806 US Route 1 Bypass
Project Description

May 17, 2024

Site Plan

806 Route 1 Bypass

AMENDED DETAILS PLAN
• MANHOLE & CATCH BASIN DETAILS REVISED

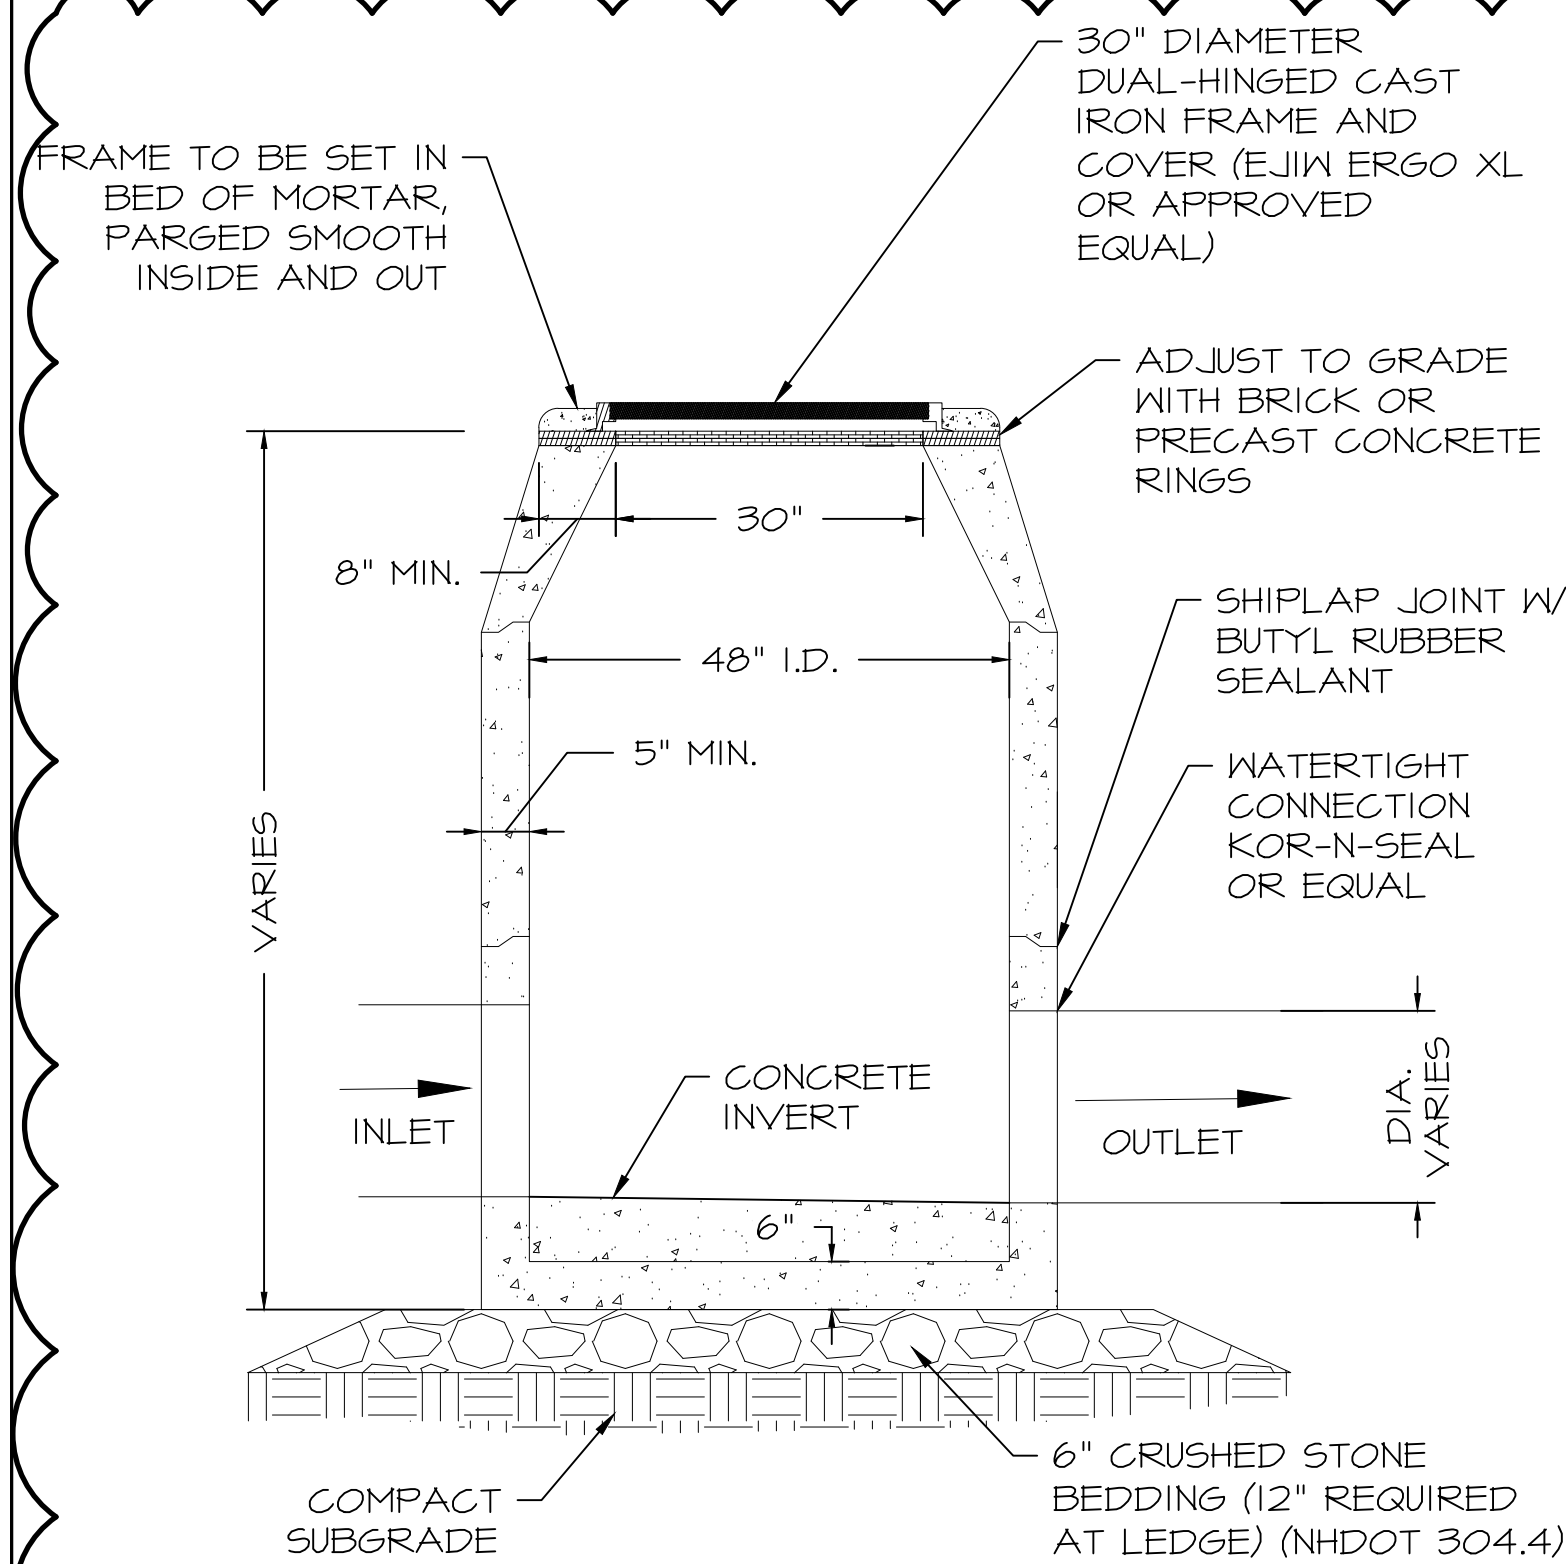
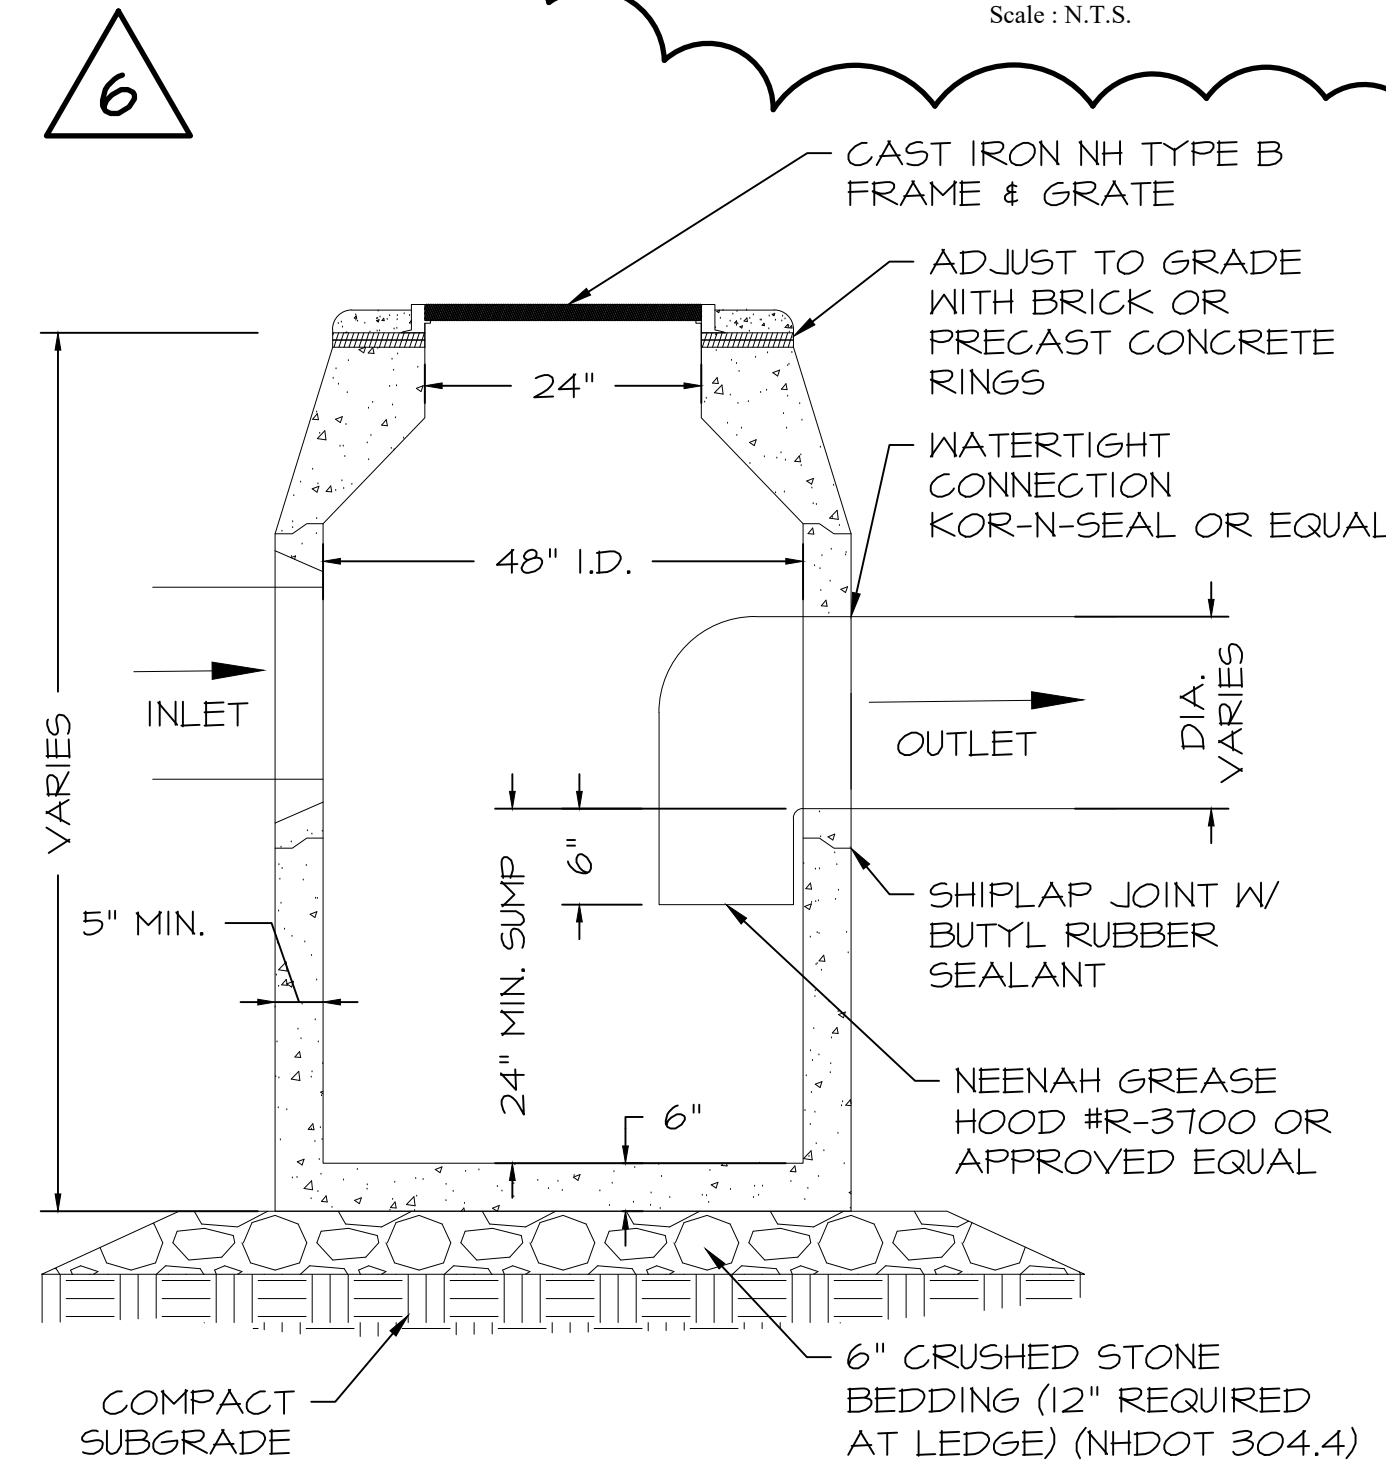
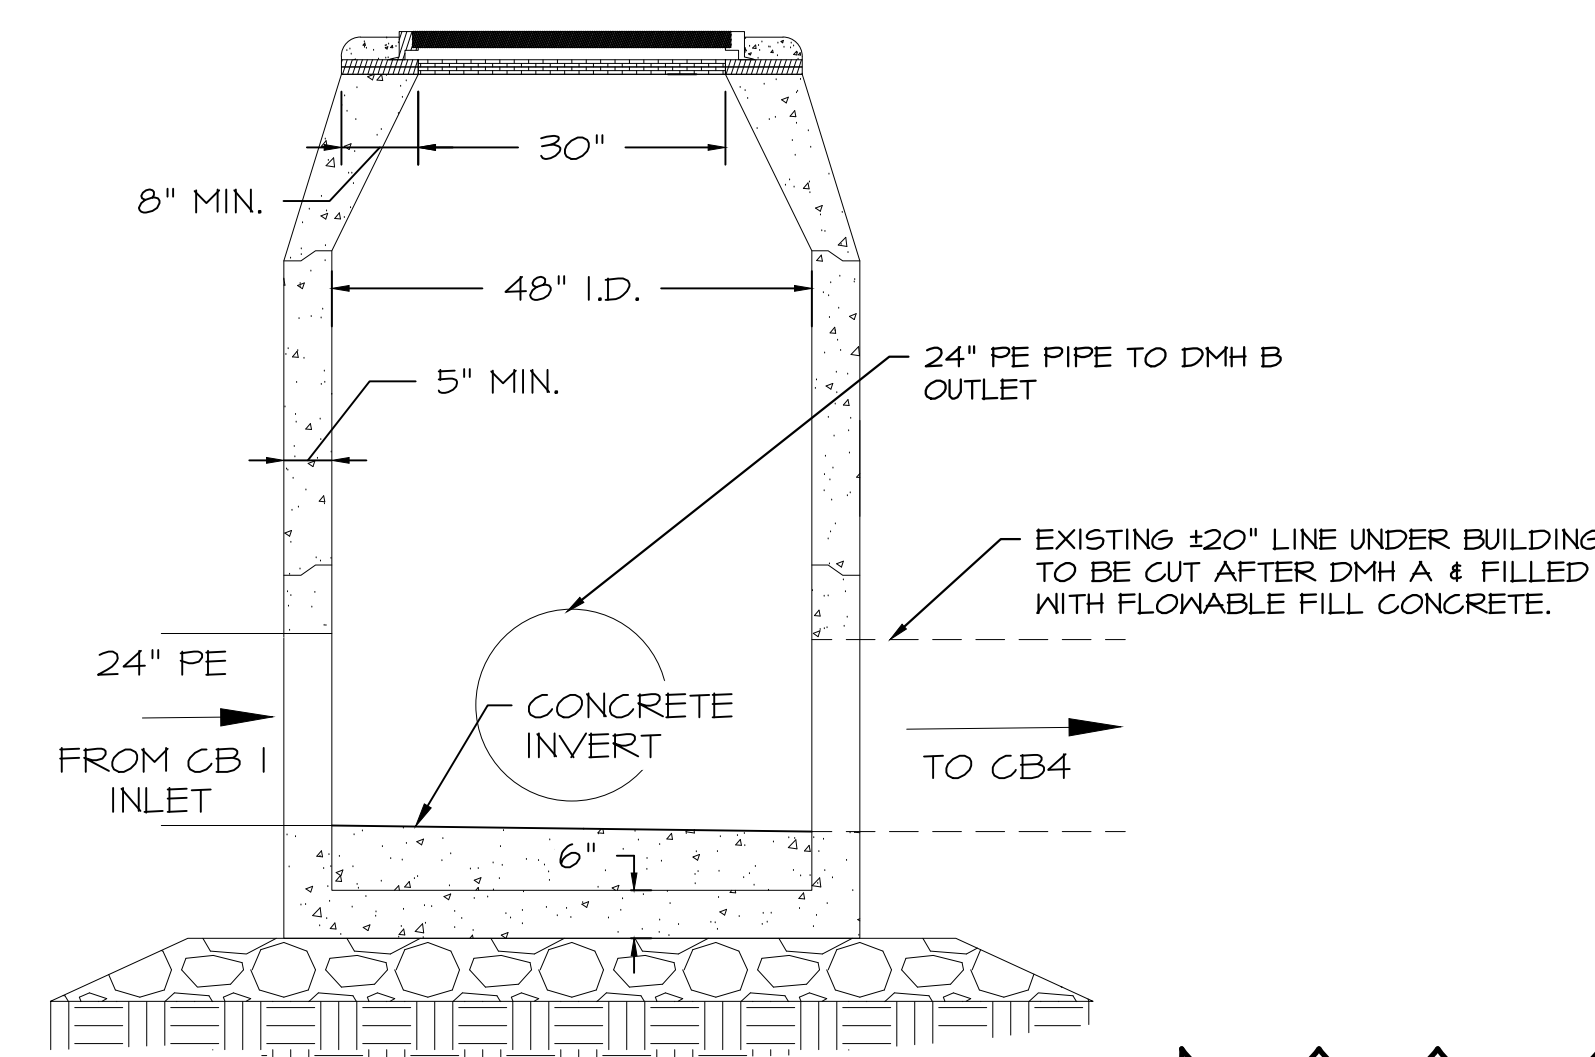
Drawing 6 – Notes & Details

- Revised manhole & catch basin details.
